OLD BEGA HOSPITAL
ARTS & CULTURAL CENTRE

DESIGN DEVELOPMENT
29.03.2018

REVIEW OF FEEDBACK ITEMS

WOMENS WARD VERANDAH

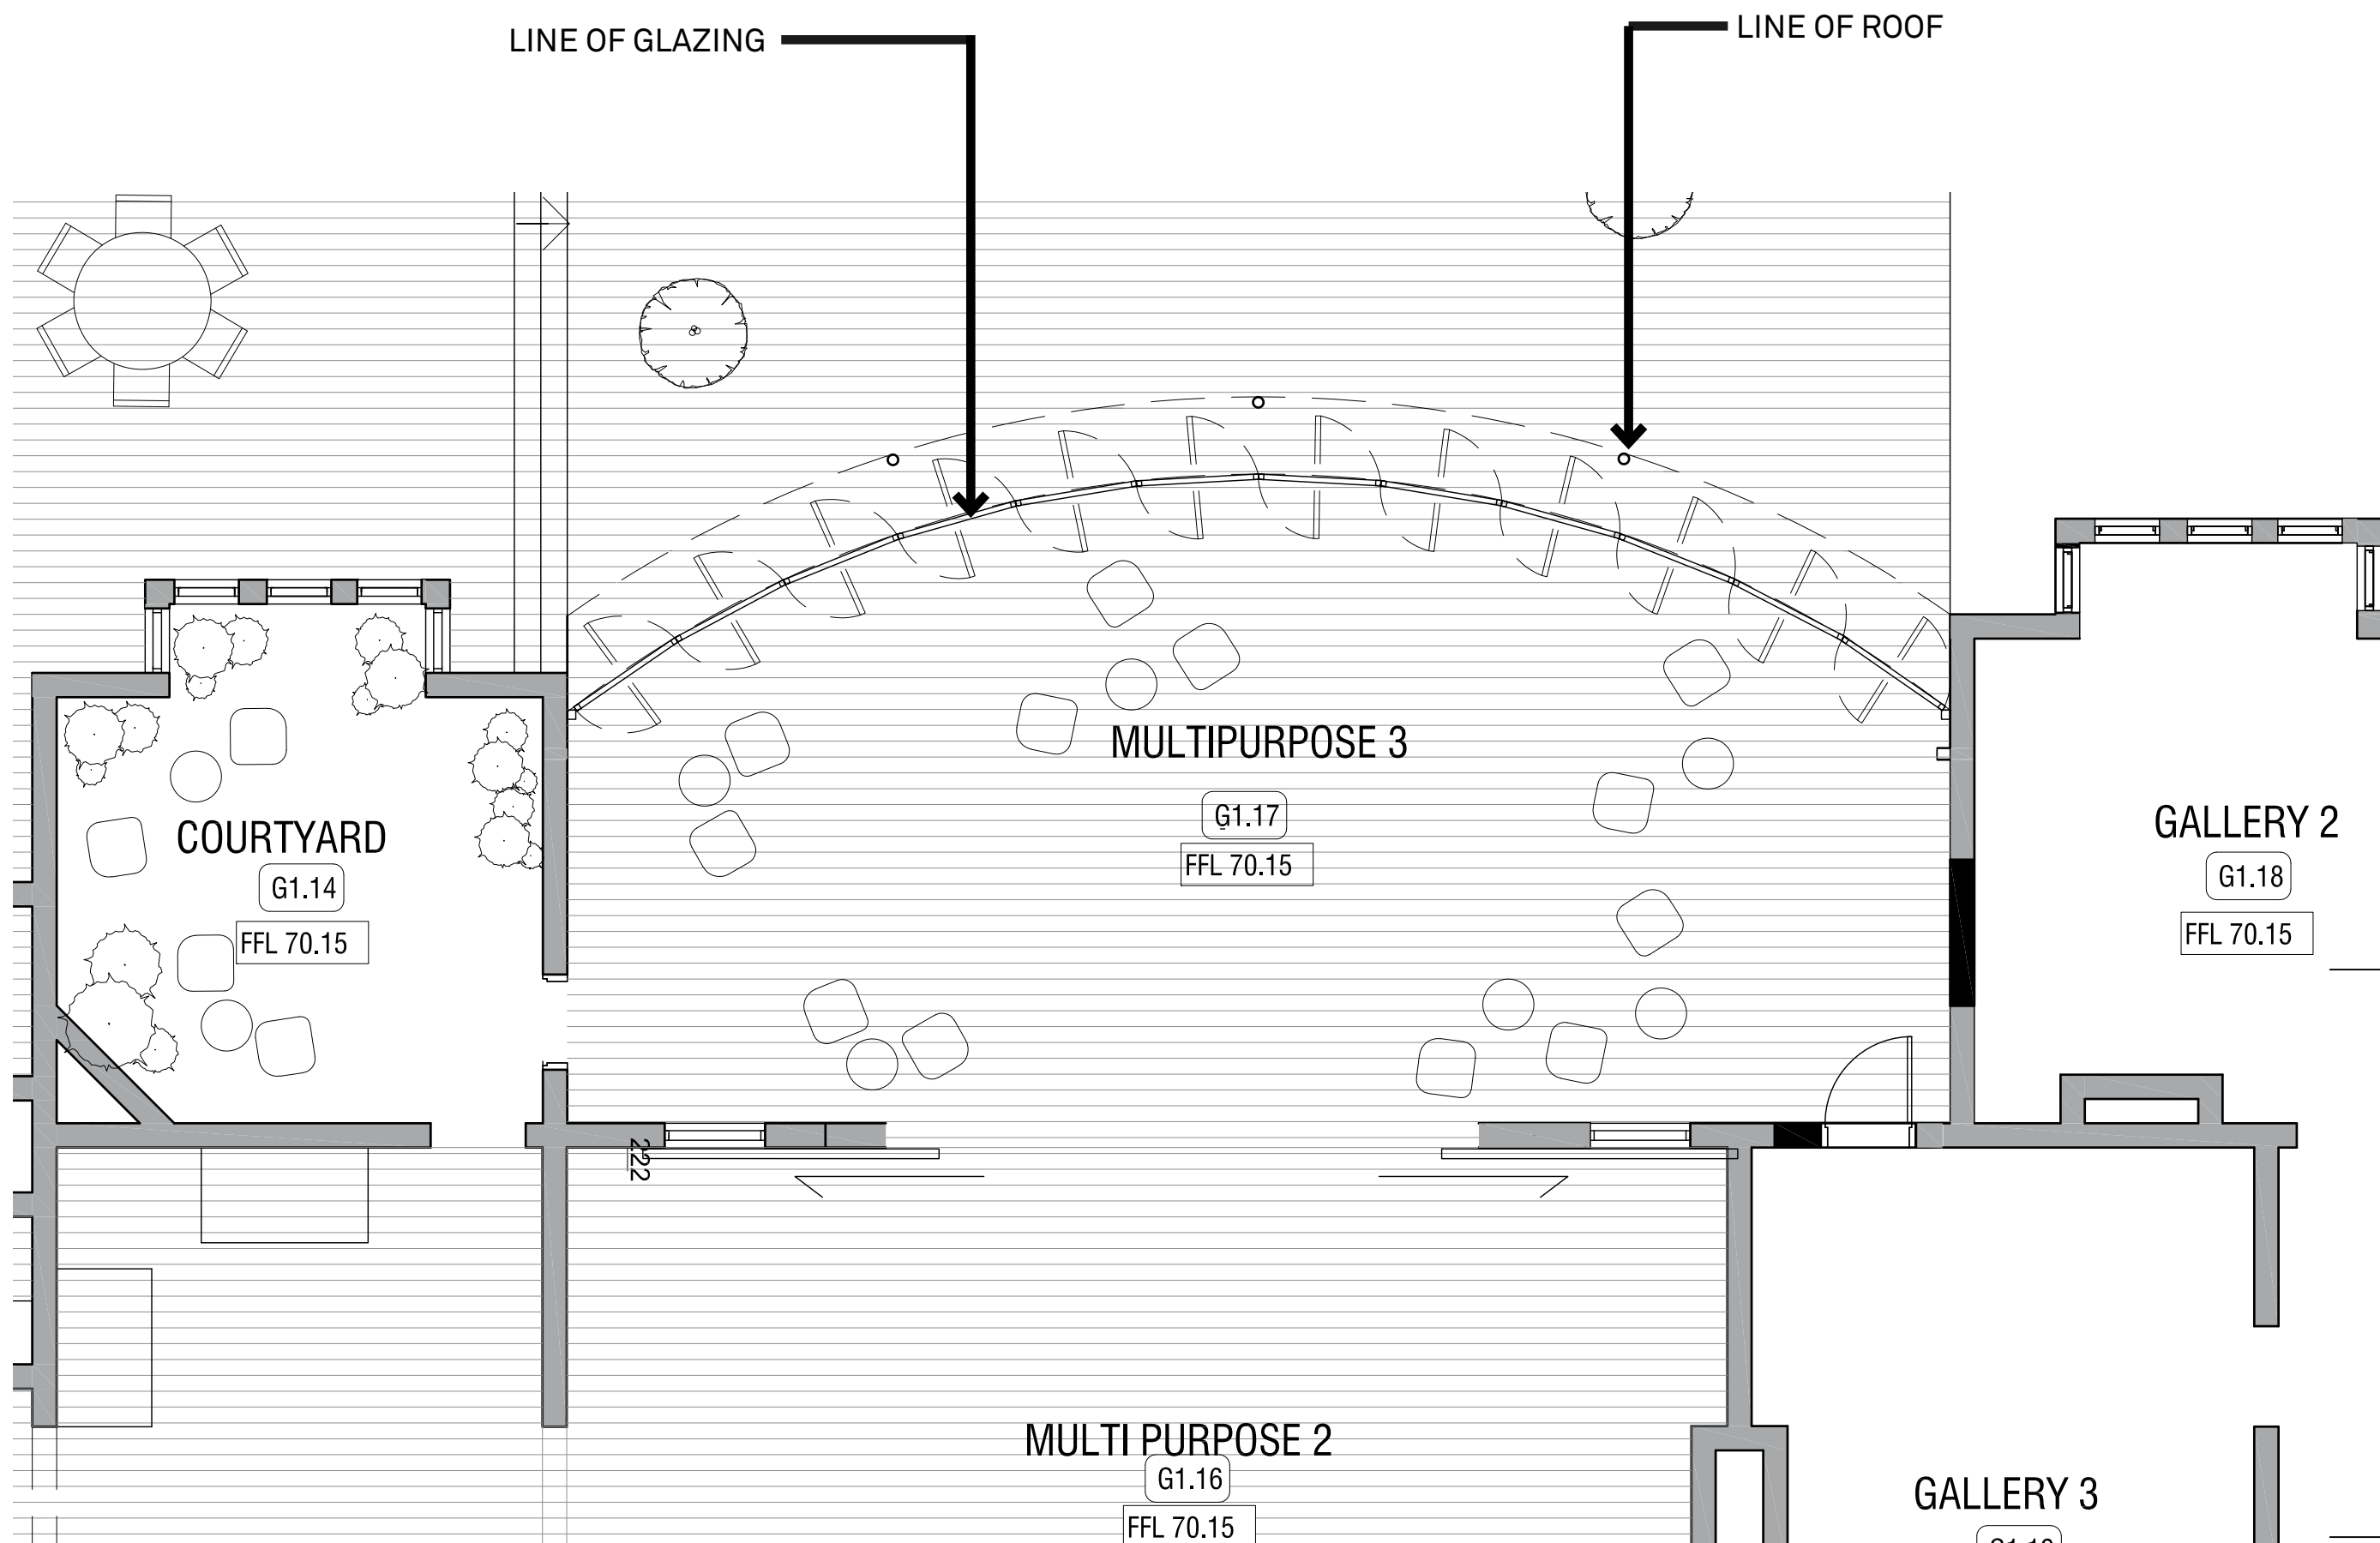
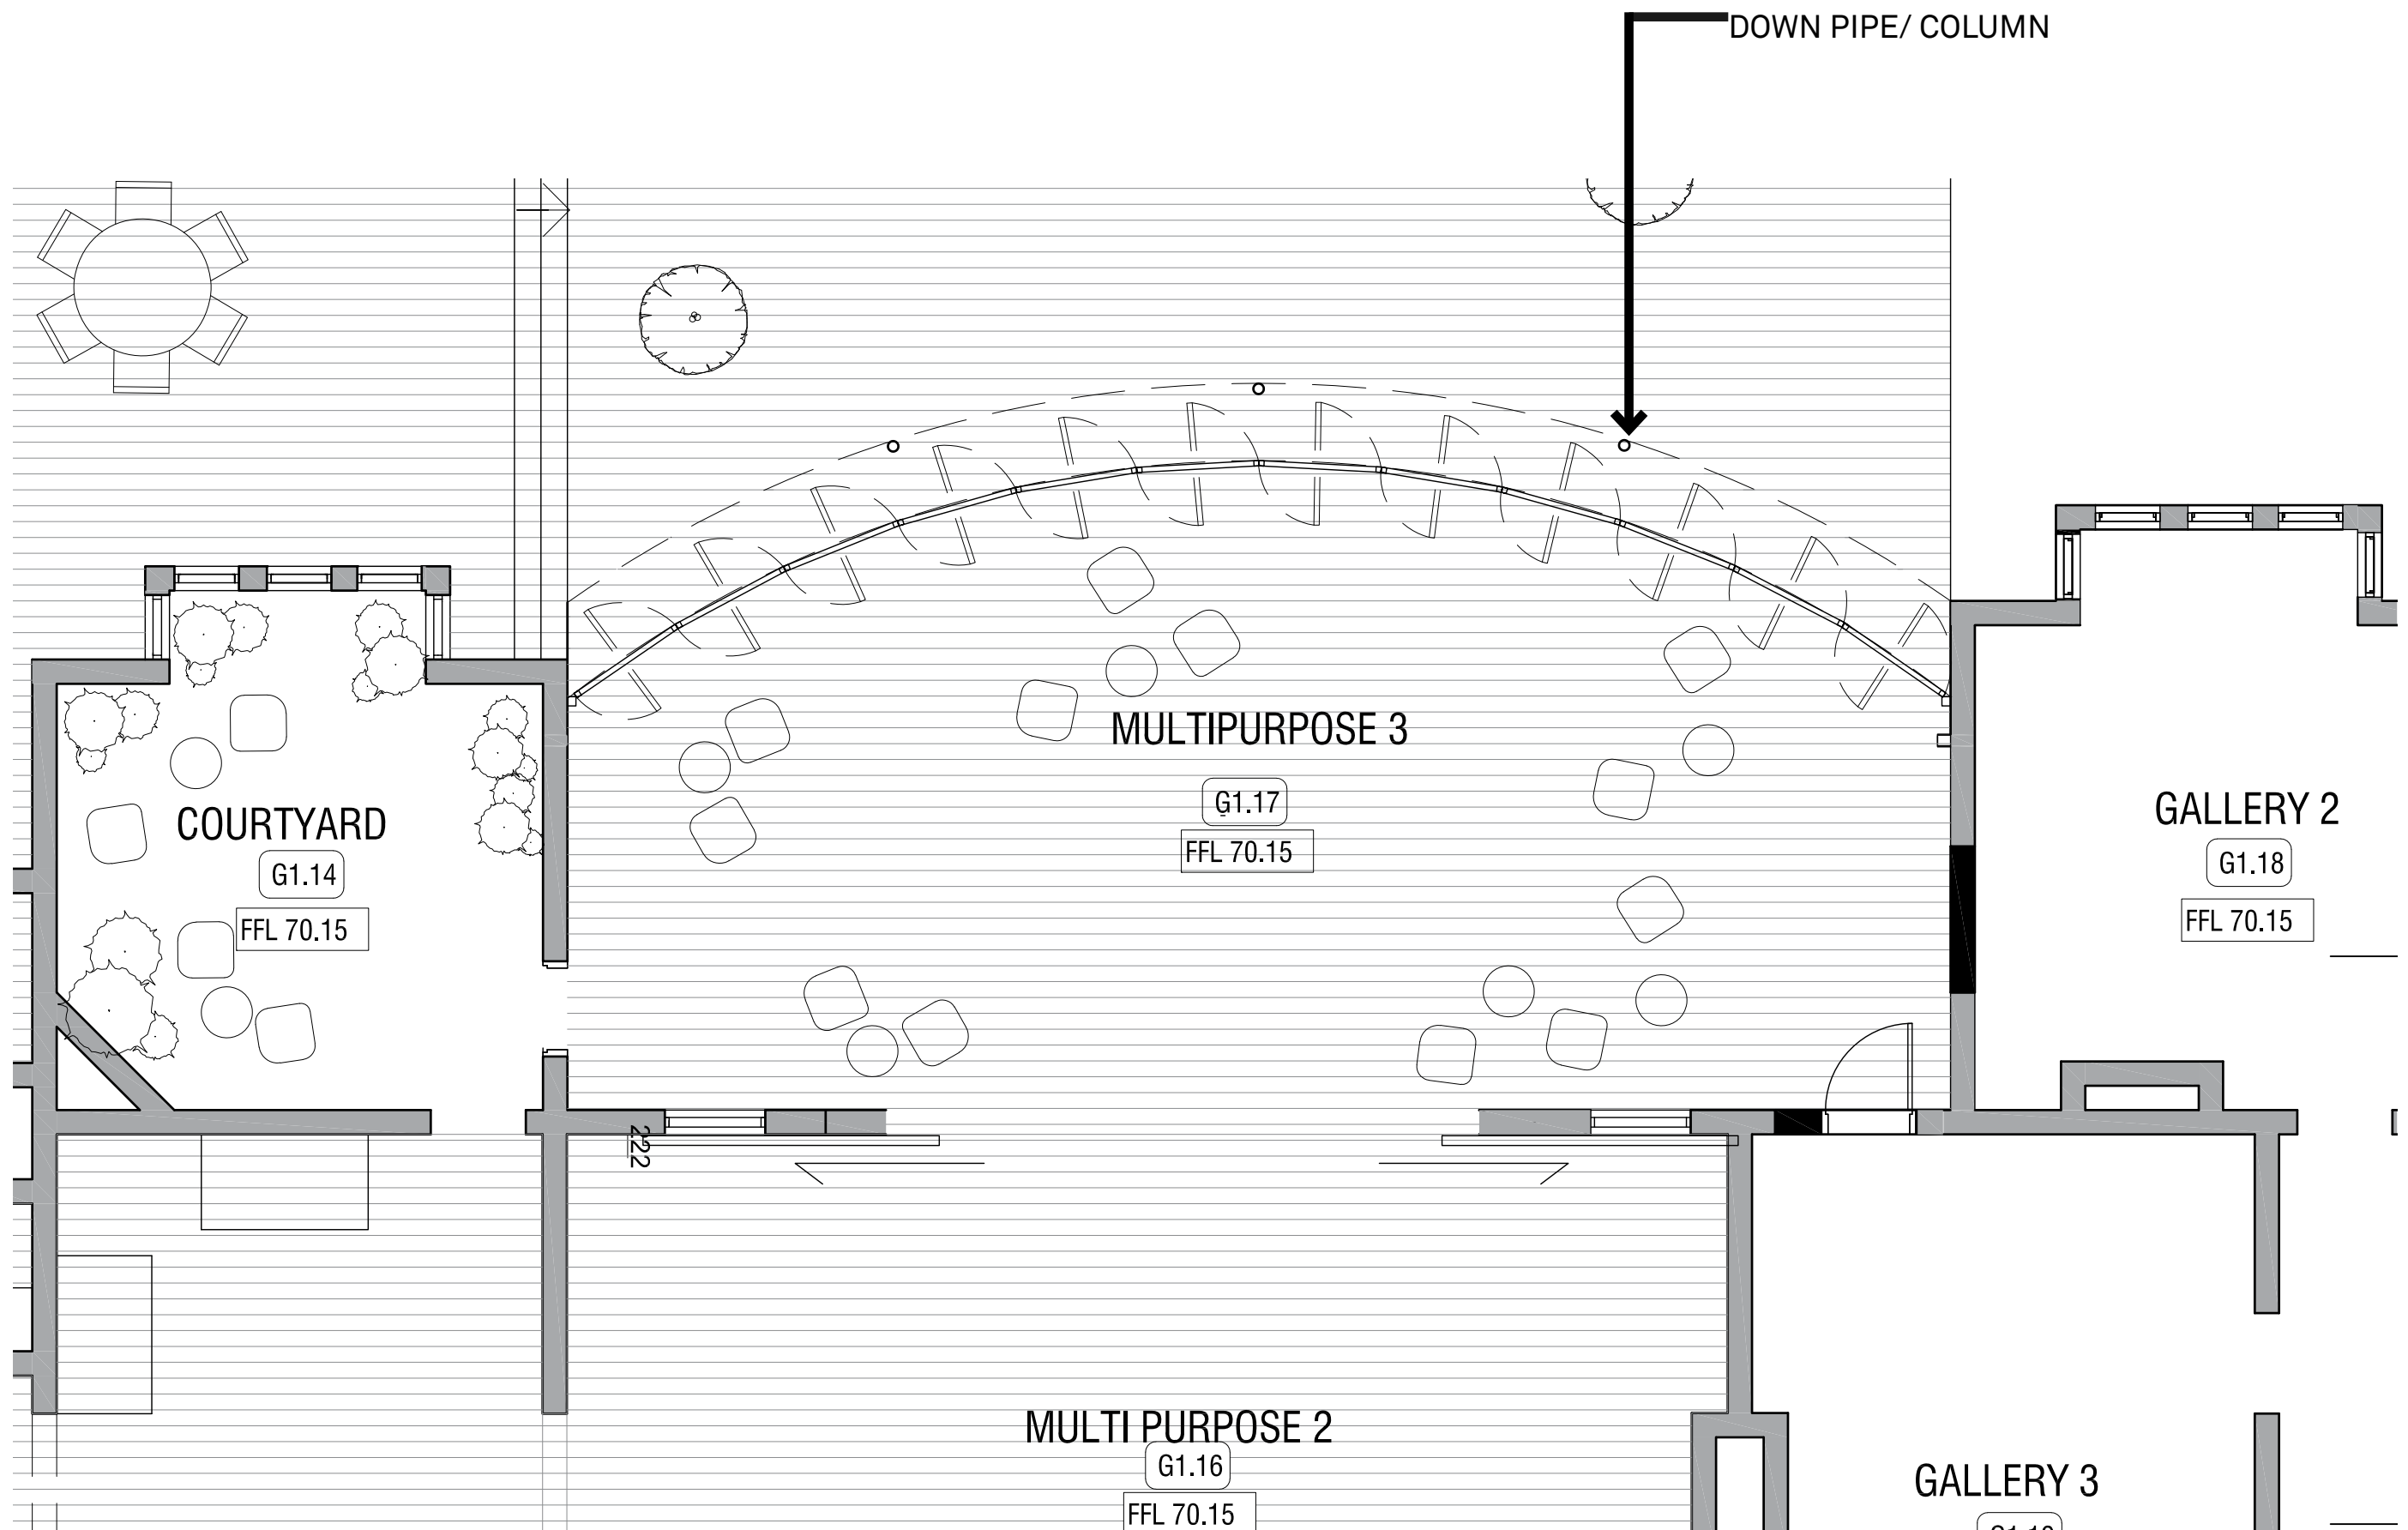
1. THE WOMEN'S WARD VERANDAH FACIA IS HIGHER (BIGGER VERTICAL DIMENSION) THAN THE MEN'S WARD FACIA. SHOULD THE MEN'S WARD ONE BE MADE TO MATCH?
2. HOW DOES THE WOMEN'S WARD VERANDAH STORMWATER COLLECTION AND DISPOSAL WORK?
3. THE ROOF OF THE WOMEN'S AND MEN'S WARD VERANDAHS SEEM TO BE ATTACHED TO THE BRICKWORK SOME DISTANCE BELOW THE WINDOWS ABOVE. WHILE THE CENTRAL VERANDAH IS ATTACHED IMMEDIATELY BELOW THE WINDOWS. DOES THAT MEAN THE WARD VERANDAH ROOFS ARE FLAT? OR DO THEY DRAIN BACK TO THE MAIN BUILDING?
4. THE WESTERN END OF THE OPERABLE OPENING OF THE WOMEN'S WARD VERANDAH DOES NOT APPEAR TO BE ATTACHED TO THE BUILDING.

HEIGHT OF ROOF WHERE IT ATTACHES TO THE MAIN BUILDING
